MEMORANDUM

Site Plan Review

820050420

The Towns of Boland Farm

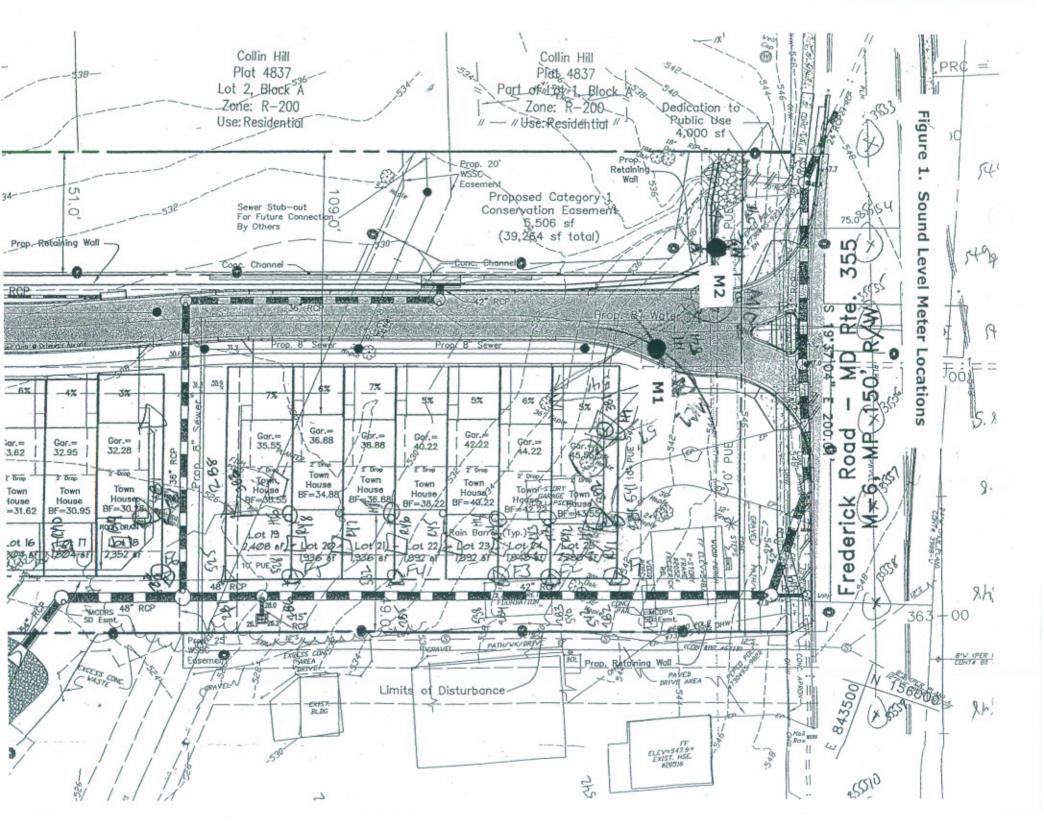
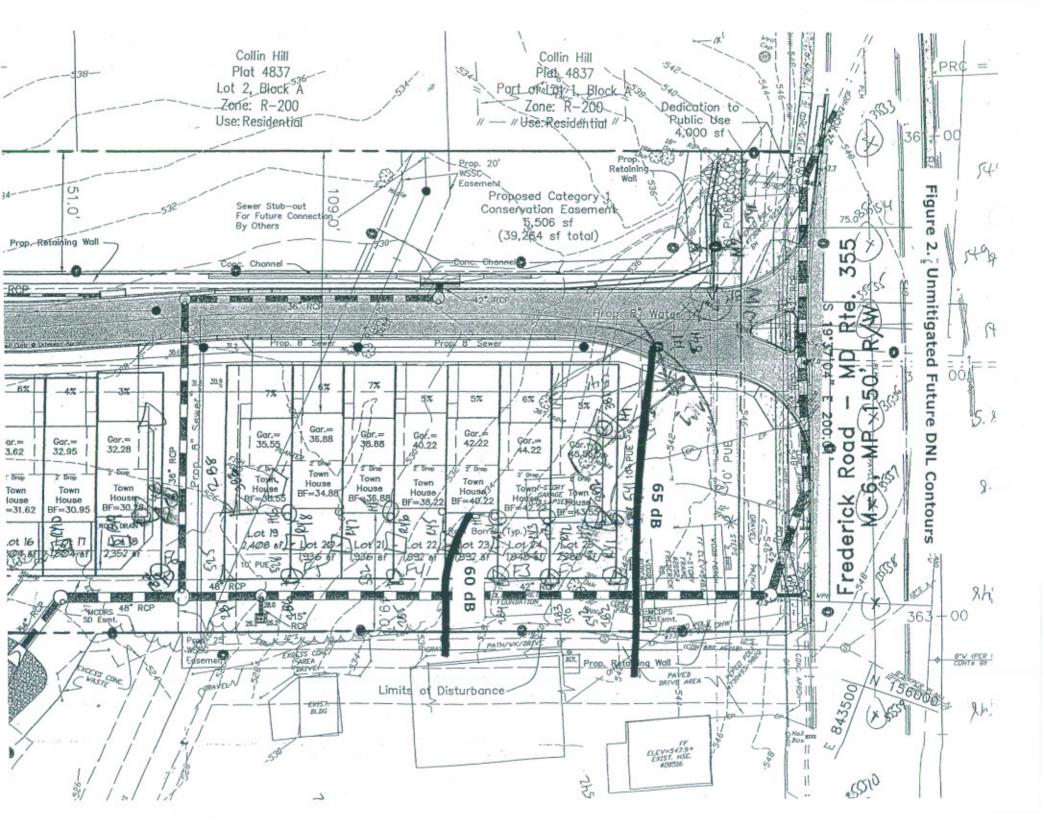
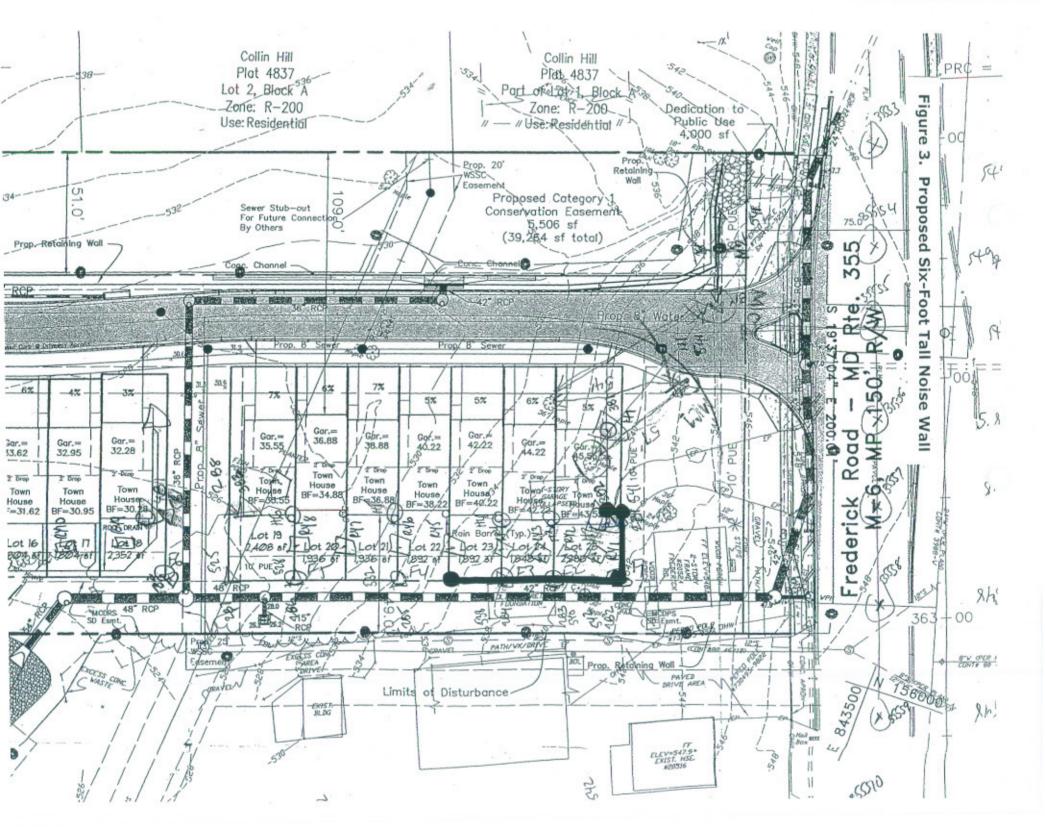
It can be seen from Figure 2 that the 65 dB DNL contour will not reach any rear yard. Therefore, no noise barriers are required if 65 dB DNL were considered to be the county criterion. However, it can be seen from Figure 2 that the 60 dB DNL contour will reach some rear yards. To be conservative we have designed a noise barrier to mitigate the DNL in rear yards to 60 dB, in case that criterion is considered to apply. We recommend constructing a six-foot tall wood board-and-batten noise wall in the location shown in Figure 3. Doors in the walls should be acoustically solid. With the proposed noise wall the DNL in rear yards will not exceed 60 dB. One acceptable noise wall construction is shown in Figure 4. Mitigated future DNL contours are shown in Figure 5. The mitigated future 60 dB contour stops at the end of the proposed noise wall, since noise levels in the yards will be less than 60 dB.
